## Runoff Calculations for Proposed Solar Farm, Barcaldine

**Development Application:** Minor Change to Development Approval (dated 15 June 2018) for Development Permit for Material Change of Use—Community Oriented Activity (Public Utility—Grid Connect Solar Photovoltaic Array) and Development Permit for Reconfiguring a Lot—Subdivision (1 Lot into 2 Lots)

## Dunblane Solar Farm – Stormwater System Modifications

PROJECT : STORMWATER SYSTEM MODIFICATIONS

Figure 3: Photo of erosion gully from stormwater channel into detention pond

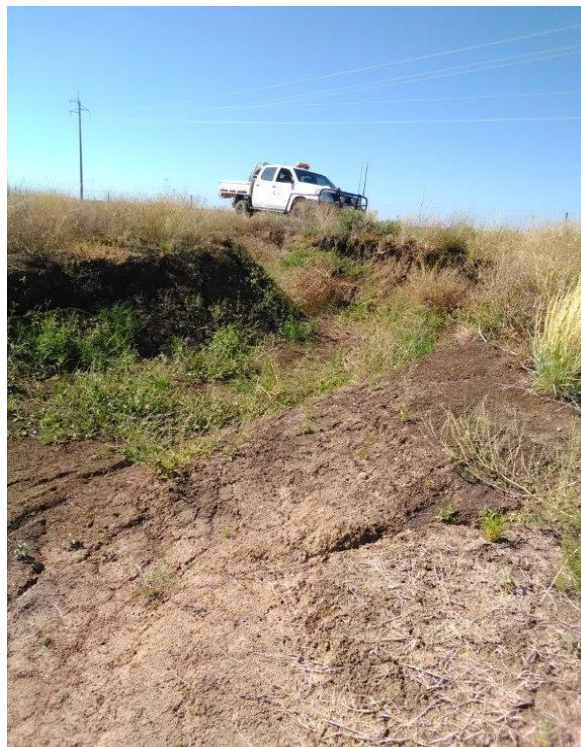
**Issue 2 – Condition 13 – Erosion at Western end of stormwater channel**

The western end of the stormwater channel has eroded a gully into the detention pond. Work required involves reconstruction of the channel from the bed of the detention pond at a slope of 1 in 10. The channel is to be shaped with a 4m wide bed and 3H:1V batter. Spoil from the excavation is to be used to backfill the erosion and make good the new channel.

The new section of channel is to be over-excavated by 200mm below the bed of the detention pond and the stormwater channel. The 200mm excavation in the stormwater drain should extend for a distance of 10m into the existing channel, past the section of the new sloped channel. Once completed, the channel and batters are to be rock lined with a rock size of between 40mm and 150mm. The rock is to extend 10m upstream of the sloped section of channel. The rock is to be spread to form an even surface and rolled to form a uniform surface across the stormwater drain.

## TYPICAL SECTION OF EXCAVATION REQUIRED TO EXCAVATE POND BATTER

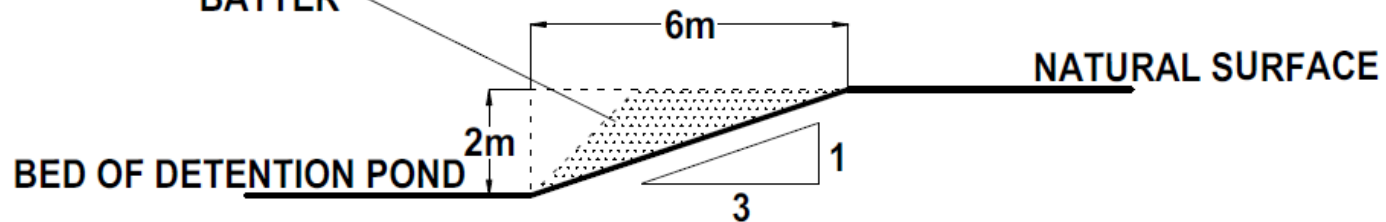
The stormwater management plan recommended 3-horizontal to 1-vertical batters. Based on the Council inspection, batters are currently at 1-horizontal to 1-vertical.

The batters are to be re-excavated to form a 3H:1V slope to reduce erosion and encourage vegetation growth to stabilise the banks. Spoil from the excavation is to be placed around the northern and eastern sides of the detention pond to prevent overland flow from entering the pond.

EXISTING 1:1 BATTER  
TO BE SLOPED TO 3:1  
BATTER
